MEMORANDUM

Location: O. S Grid Ref: 352 520 The Goulbourne, Borrass Park Road, Wrexham.

Development: Residential development (8 no. detached dwellings) and construction / alteration to vehicular and pedestrian access.

I refer to your email / consultation dated 16/05/2017 including layout plan (Drg. No. N027 / 014 Rev H) in respect of the above.

Turning Areas

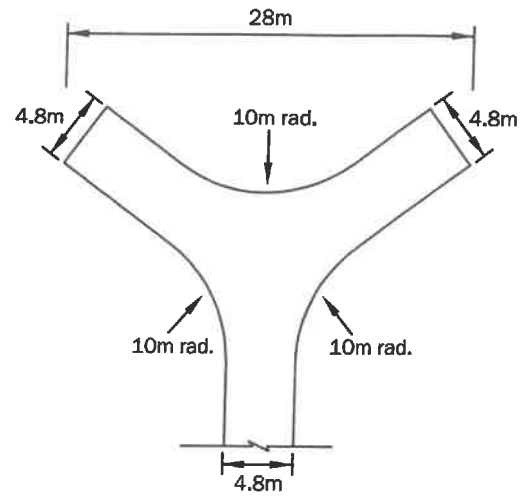
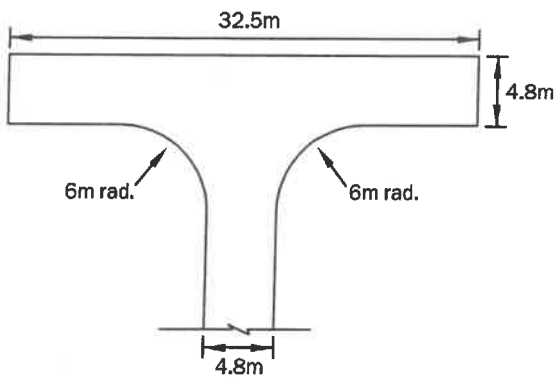
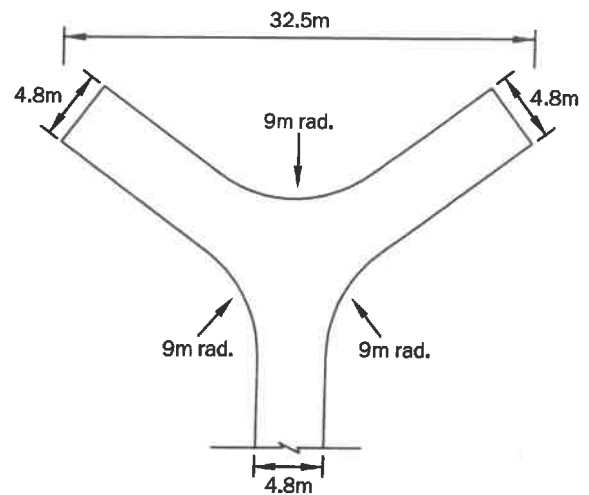
The proposed turning head is of insufficient size and does not comply with WCBC adoptable standards. **I would recommend that the applicant submits a revised layout plan indicating a turning head which complies with our adoptable standards (see attached details).**

Turning areas are based on an 11.18m long, 2.55m wide refuse vehicle.
